Mark A McLaughlin,
Director of Environmental Services
ATTN: San Francisco to San Jose
California High Speed Rail Authority
100 Paseo De San Antonio, Suite 206
San Jose CA 95113

re: San Francisco - San José Project Section EIR Scoping Questions

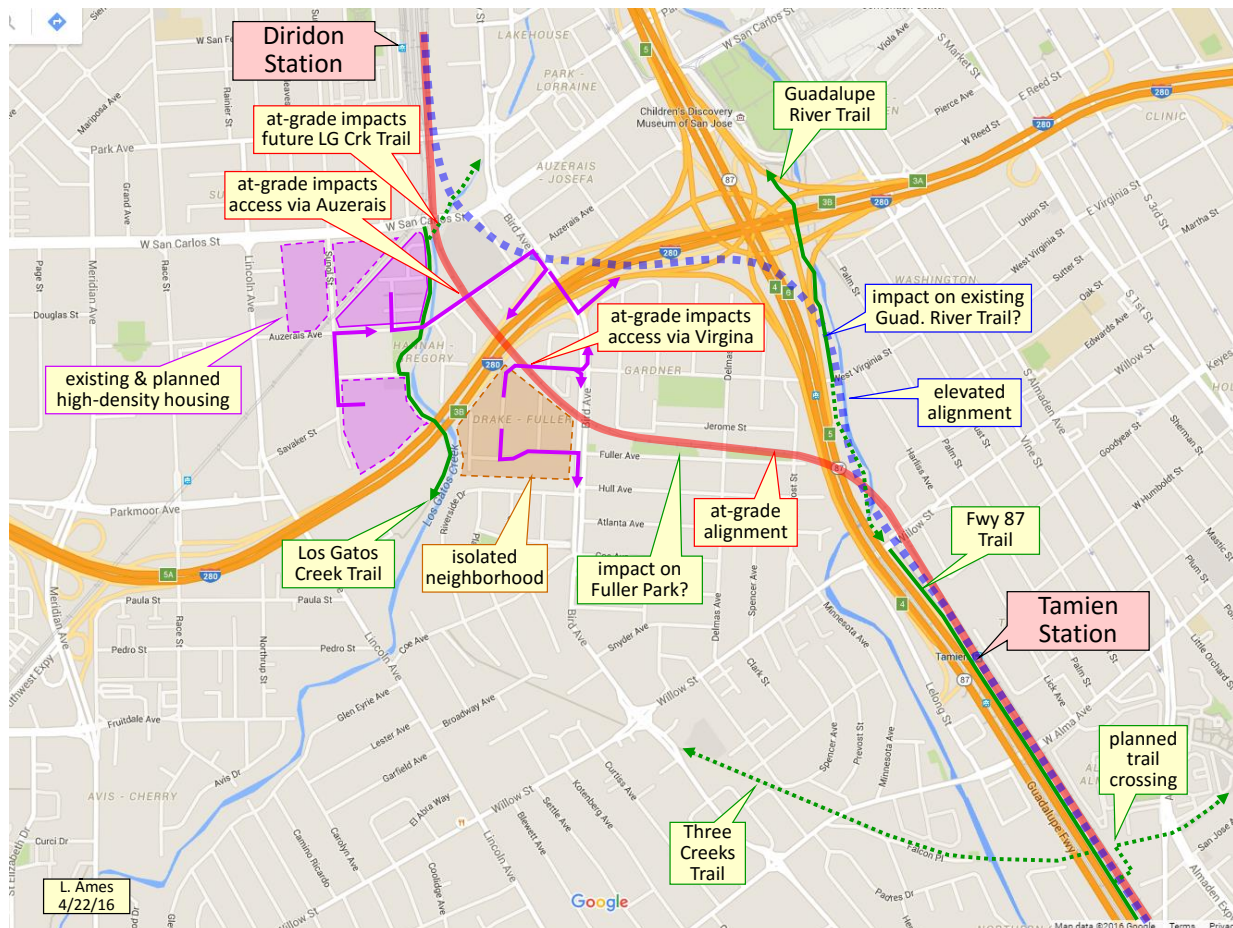
Q5: The choice of at-grade vs. elevated has major impacts on several neighborhoods just south of the Diridon Station: Midtown, northern Willow Glen, and the Greater Gardner District. These areas are not exactly home to “the top 1%”, and they have been impacted for years by freight trains, freeways, and aircraft overflights en route to San José International (SJC). [As shown in red in the graphic below, the at-grade alignment between Diridon and Tamien Stations follows the existing CalTrain alignment while the elevated alignment (dashed blue) is primarily within the right-of-way of Freeways 87 and I-280. The third possible alternative, “underground”, would not have the issues I list here but has a number of other problems.]

My concerns:

- The at-grade alignment into Diridon would impede or sever Virginia Street, the main access route to and from an isolated neighborhood shown in tan on the map. The only other access to this community is limited to right-turn-in / right-turn-out.

- A number of existing and planned mid- to high-density housing complexes (shown in purple) use Auzerais as a principal access to the freeway. The at-grade HSR alignment would impede or sever this access route, inconveniencing the residents and affecting traffic patterns throughout the region.

- Using the existing rail alignment would require additional tracks, given that one of the current two tracks is dedicated for freight. The added tracks would likely infringe upon Fuller Park

- The at-grade route will require a new crossing of the Los Gatos Creek. This bridge is already planned for replacement (see below), and coordination work needs to be done to assure its design is compatible with the planned extension of the Los Gatos Creek Trail into Downtown.

The aerial alignment would generally be within the right-of-way of the freeways and would have much less impact on the neighborhoods. It would also give arriving passengers a great view of the City. Care

would be needed, however, to avoid impacting the Guadalupe River Trail into Downtown (shown in green in the graphic).

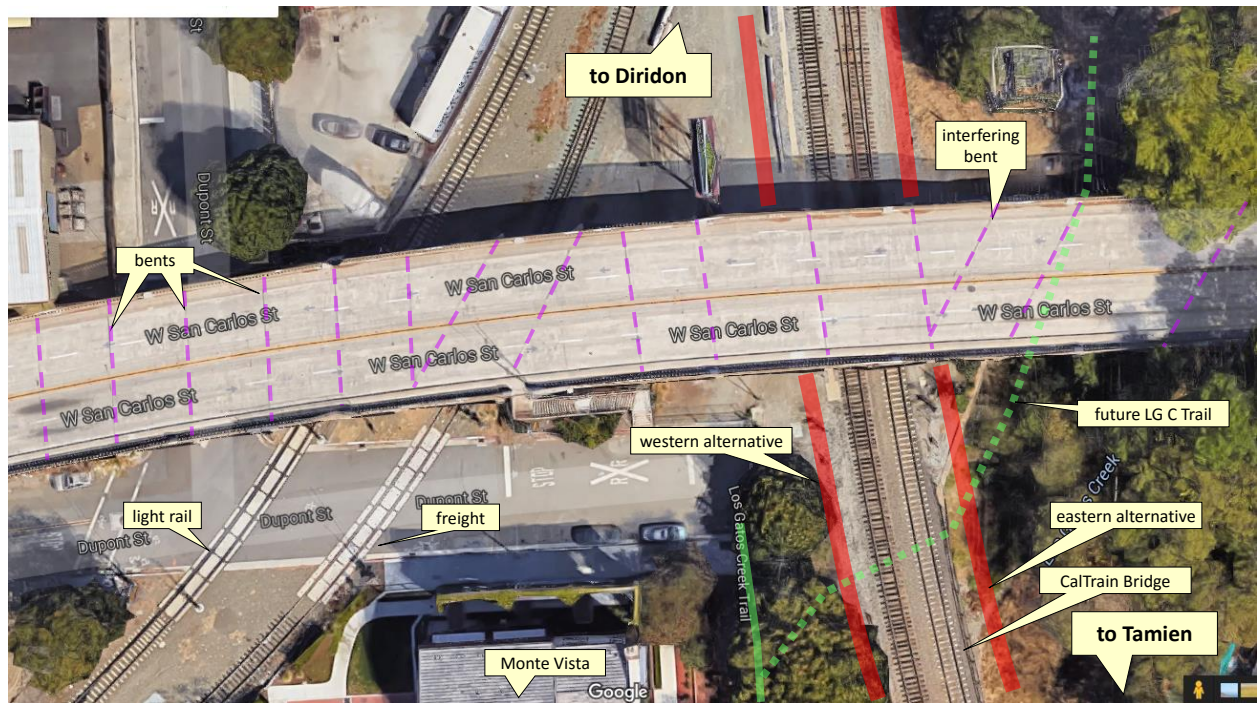
As a retired aerospace engineer, I would like to offer an alternative solution that I recently (finally!) found: just make a minor retrofit to the existing San Carlos Street Bridge and then build the third track on the eastern side where the impacts are less severe. The following graphic illustrates the issues:

- The San Carlos Street Bridge is supported by numerous “bents” (lines of pilings or supporting walls): their positions and orientations can be seen in the graphic by the expansion-gaps in the bridge (highlighted in purple). Note that some of the bents are perpendicular to the bridge alignment, while others are angled to align with the Los Gatos Creek or with the freight tracks heading to the southwest.
- If the train bridge is expanded to the west (left red line), the tracks can easily pass under the San Carlos St. Bridge between a parallel set of bents. However, for the eastern alignment, the way is blocked by a bent that is parallel the Los Gatos and that angles across the potential track alignment.

The photo above to the left shows the offending angled bent, and the photo to the right shows the solution: the bent can be reconstructed, with a new piling on either side of the track and a new “cap” across the top. It appears that the San Carlos Street Bridge has already been retrofitted once, when the light rail tracks were installed a decade or two ago. (This bent alignment is readily visible in aerial view, crossing the light rail tracks.) The bent labeled “interfering bent” could be similarly retrofitted to enable the better eastern alignment.
